Access Compliance Report Public Rights-of-Way (Curb Ramps)

Main Street: DELPHINIUM_ST		Cross Street: TRUMPET_VINE_ST		Location:	NW
ADA ID: RPAT211102103259	Ramp Type: Type 4 - Parallel	Initial Pass/Fail: Fail	Overall Compliance: No	Severity Score:	2
Codes/Mitigation Info/Possible Solution			Field Measurements/Component Compliance

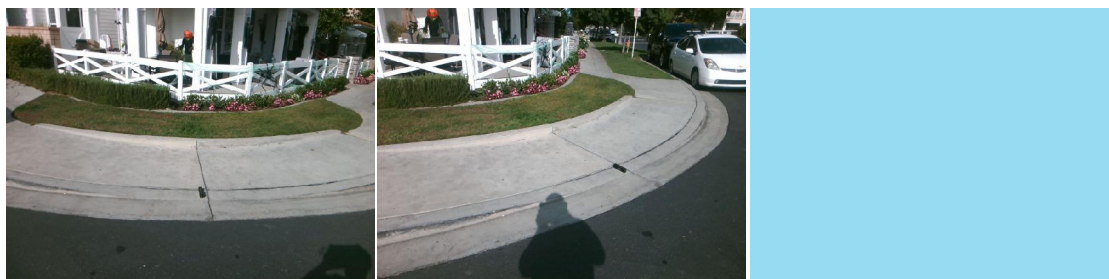
Compliance	Description	Data	Compliance	Description	Data
N/A	Ramp Length LT (in)	112	N/A	Ramp Length RT (in)	100
Yes	Ramp Width LT (in)	52	Yes	Ramp Width RT (in)	53
Yes	Ramp Run Slope LT (%)	4.3	Yes	Ramp Run Slope RT (%)	3.8
No	Ramp Cross Slope LT (%)	3.9	No	Ramp Cross Slope RT (%)	2.7
N/A	Landing Present	N/A	N/A	DWS Provided	N/A
N/A	Landing Length (in)	N/A	N/A	DWS Contrast	N/A
N/A	Landing Width (in)	N/A	N/A	DWS Length (in)	N/A
N/A	Landing Run Slope (%)	N/A	N/A	DWS Full Width	N/A
N/A	Landing Cross Slope (%)	N/A		DWS Offset Type	N/A
N/A	Landing Movement Obstructed?	N/A	N/A	DWS Offset Left (in)	N/A
	Landing Movement Type	N/A	N/A	DWS Offset Right (in)	N/A
N/A	Landing Shared	N/A			
N/A	Clear Space	Yes			
N/A	Clear Space To Crosswalk (in)	N/A			
N/A	Marked Crosswalk 1	No	N/A	Marked Crosswalk 2	No
	Crossing 1 Direction	S		Crossing 2 Direction	E
	Marked Crosswalk 1 Width (in)	N/A		Marked Crosswalk 2 Width (in)	N/A

Remove & Replace Curb Ramp With Two New Directional Ramps or Equivalent.
